PUBLIC UTILITIES COMMISSION OF THE STATE OF CALIFORNIA

Resolution SPD-9
December 15, 2022R E S O L U T I O N**RESOLUTION SPD-9. Resolution Ratifying Action of the Office of Energy Infrastructure Safety on Pacific Gas & Electric Company's 2022 Wildfire Mitigation Plan Update Pursuant to Public Utilities Code Section 8386.**

**OFFICE OF ENERGY INFRASTRUCTURE SAFETY'S
FINAL DECISION ON 2022 WILDFIRE
MITIGATION PLAN UPDATE**

Figure 4.2-3: Net Change from 2021 to 2022 WMP Reporting Period (\$ Thousands)

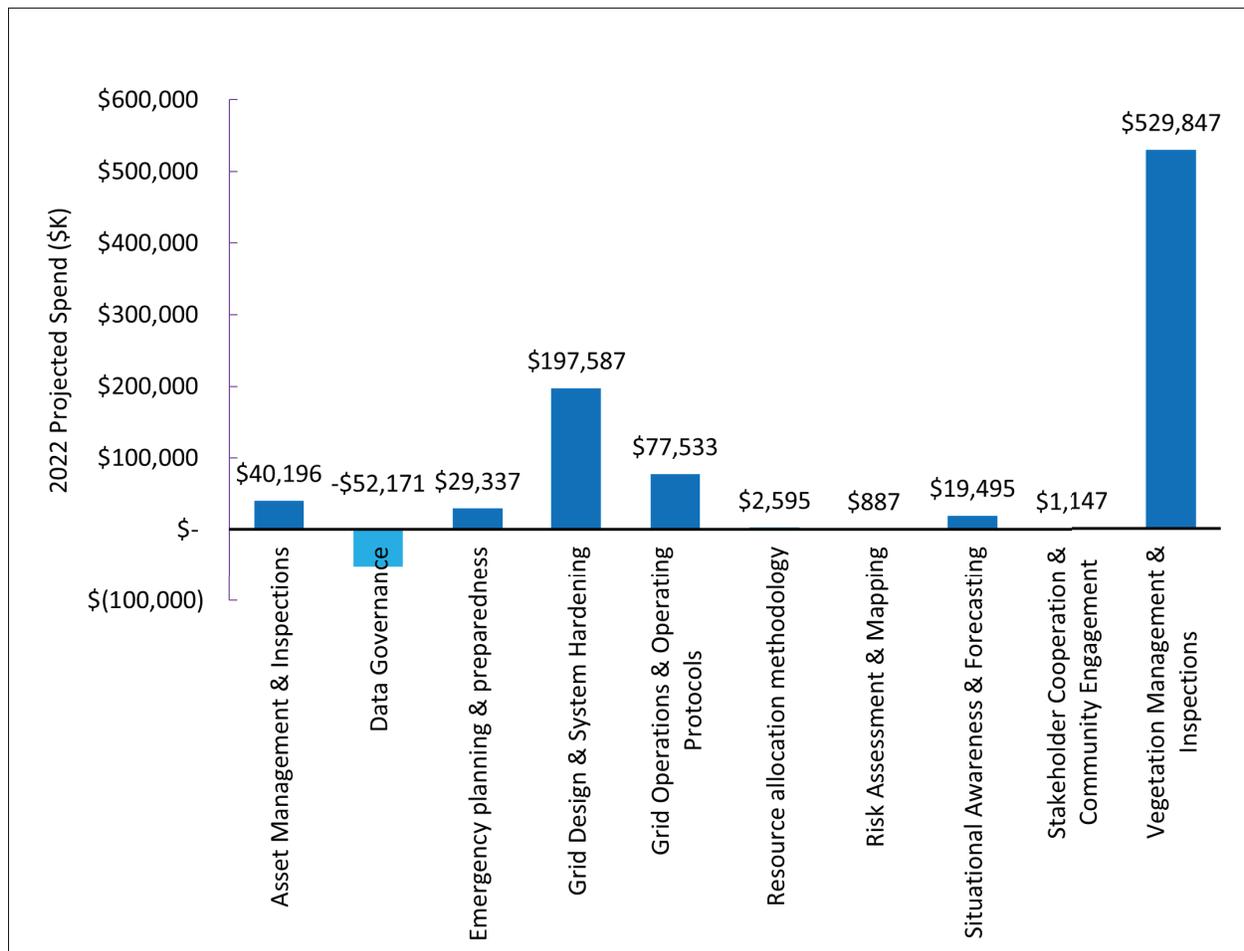
Energy Safety requested additional information about the largest changes in mitigation category spending when comparing expenditures included within PG&E's 2022 Update to expenditures projected for 2022 in PG&E's 2021 Update, as shown in Figure 4.2-3. Energy Safety asked about the following category expenditure changes:

PG&E responded that the increases in spending in the vegetation management category initiatives in the 2022 WMP are greater than the forecast in the 2021 WMP in order to account for updated estimates of work required in 2022. This included the need to address an increased volume of dead trees (attributed to the current drought impacting the Tree Mortality, Enhanced Vegetation Management (EVM), Transmission, and One Vegetation Management Programs.

Figure 4.2-4: PG&E Cumulative Increase in Cost to Ratepayers Due to Utility-Ignited Wildfires and Mitigation Activities (Average Increase to Monthly Electricity Bill in Dollars, 2020-2022)

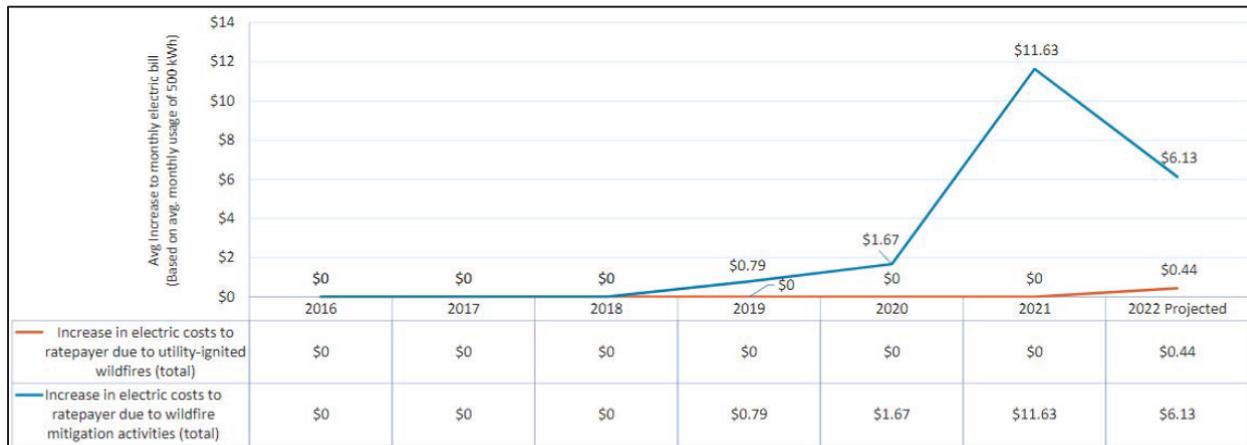
When comparing ratepayer electric costs for wildfire mitigation activities and ignitions across the large IOUs' 2022 Updates,³⁰ PG&E's increase in electric costs to ratepayers over the 2017-2022 period (Figure 4.2-4) is markedly steeper than the increase for SCE and SDG&E for the same period. Energy Safety asked PG&E to explain the large discrepancy in electric costs to ratepayers due to wildfire mitigation activities as compared to its peer utilities. In response, PG&E indicated vegetation management and inspections and grid design and system hardening are the major cost drivers of the current WMP cycle. PG&E also indicated that some of the differences in costs may be related to regulatory timing for cost recovery. Thus, SCE's

Figure 4.6.1-6: PG&E Wildfire Distribution Risk Model (WDRM) V2 vs. V3 Risk Scores⁹⁶

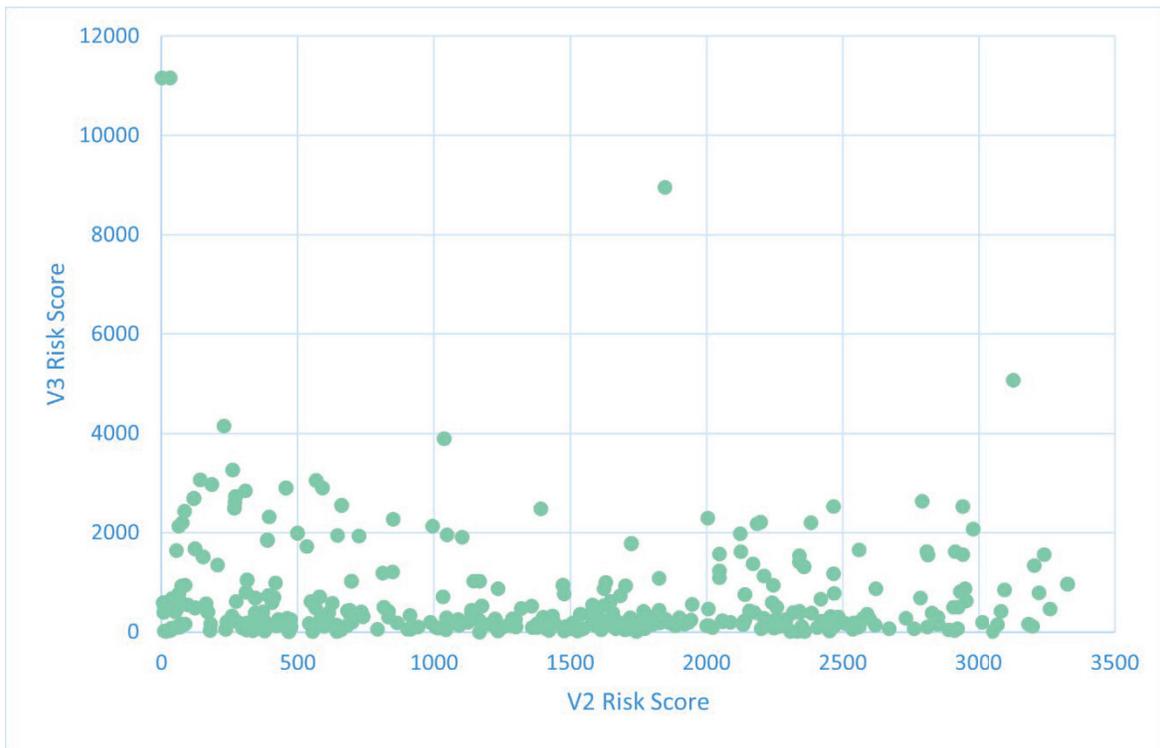
PG&E moved from Version 2 (V2) of the WDRM to Version 3 (V3). While prioritization shifts were not as drastic as those seen when adopting V2 of the WDRM, this transition did lead to a distinctive shift in prioritization. For the undergrounding projects from 2024 to 2026, no observable correlation between the V2 and V3 risk scores can be seen, as shown in Figure 4.6.1-6.⁹⁴ Additionally, when looking at all Circuit Protection Zone (CPZ)⁹⁵ risk scores, it is clear that the V2 scores lie throughout the cumulative V3 risk, with few being in the top 60 percent of cumulative risk, as shown in Figure 4.6.1-7. While Energy Safety supports improvements being made to PG&E's risk models, it is concerning that the output of risk scores continues to change in relatively drastic ways, leaving open the question of the validity not only of past models, but the current one given anticipated additional future improvements. PG&E must demonstrate an understanding of the impact of the changes made between its V2 and V3 models in order to further validate continued confidences in the risk model outputs, particularly relating to projects that may be stranded due to changes in prioritization.

Figure 4.6.4-5: Distribution Tags based on Closing Backlogged Tag Goals

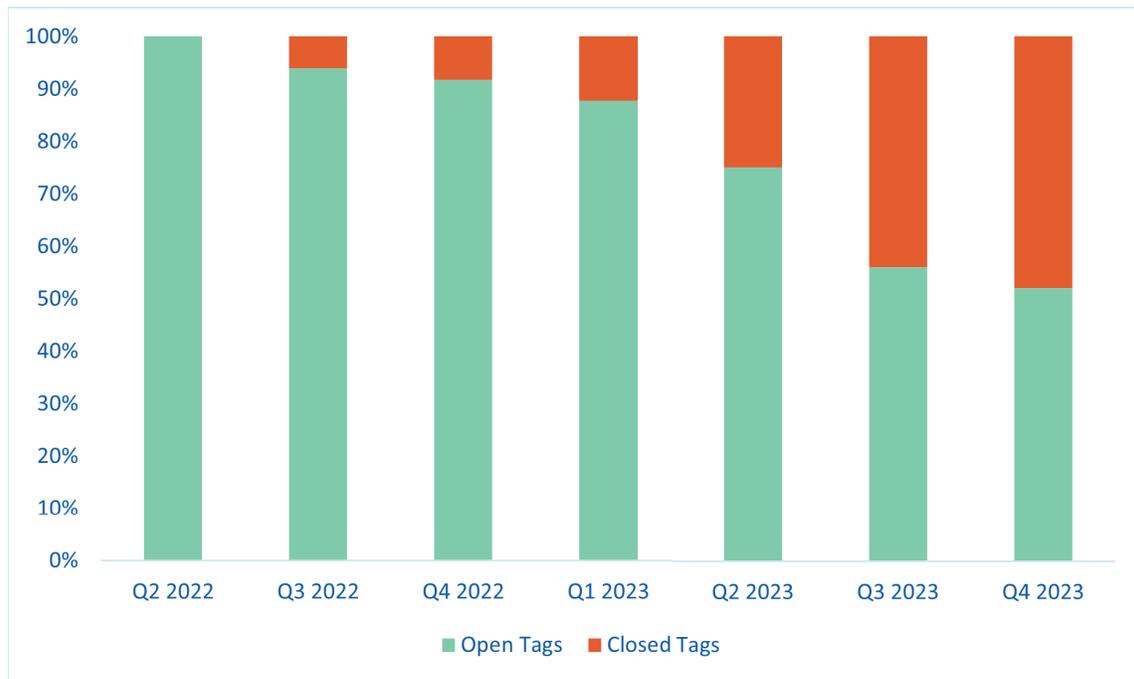
Despite providing quantitative goals to address the work tag backlog, PG&E is still creating more work tags than it is closing, as shown in Table 4.6.4-1. In the Revision Notice, Energy Safety discussed addressing the backlog by setting targets in which PG&E closes more work tags than it opens. Even with the goals provided in PG&E's Revision Notice Response, 52 percent of the open work tags for distribution will still be open at the end of 2023.

PG&E has de-escalated the critical issue RN-PG&E-22-05. PG&E provided a spreadsheet with the required information, as well as quantitative targets for 2022 and 2023. PG&E's targets for distribution are shown in further detail in Figure 4.6.4-5. It should be noted that the total number of work tags used in this figure is static based on the number of open distribution tags. Although PG&E still has a long way to go to come into compliance with GO 95 requirements and to reduce its backlog to a steady state, by committing to firm reduction targets and dispensing with the practice of continually re-starting the clock on repairs, PG&E's response to its Revision Notice is a significant step in the right direction. It should also be noted that this is not indicative of the additional tags that will be opened per quarter.

Figure 4.6.4-6: PG&E's Changes to Projected Distribution Ignitions¹⁵³

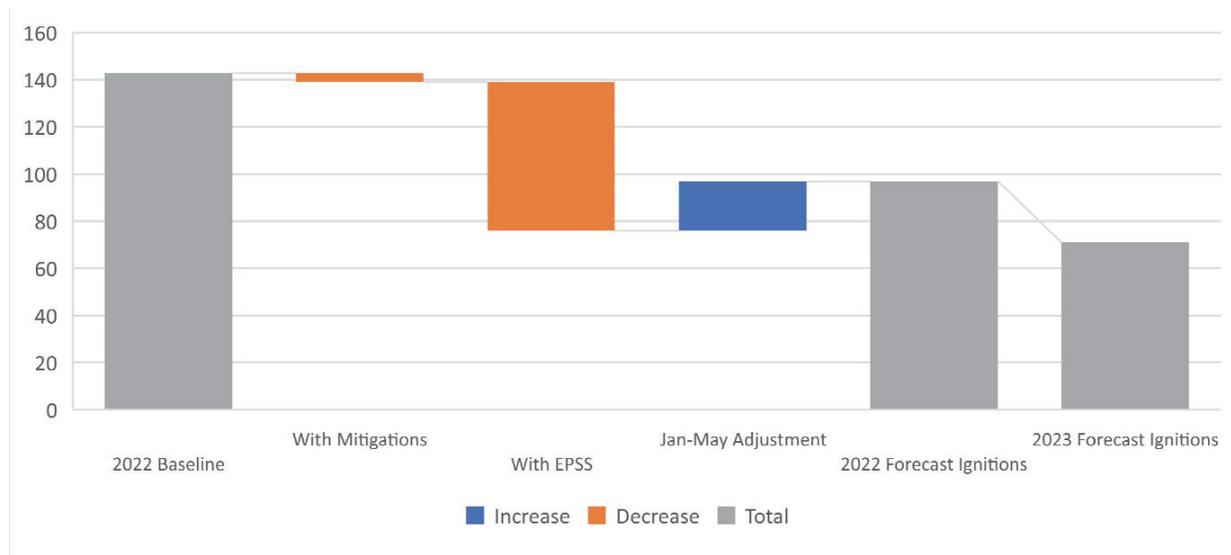
As shown in Figure 4.6.4-6, most of the decreases in the 2022 baseline ignitions are due to EPSS implementation, with minimal decrease from additional initiatives outside of EPSS. PG&E stated that, excluding EPSS, it expects ignitions to decrease by 3 percent from 2021 to 2022, and by approximately 7.4 percent from 2022 to 2023.
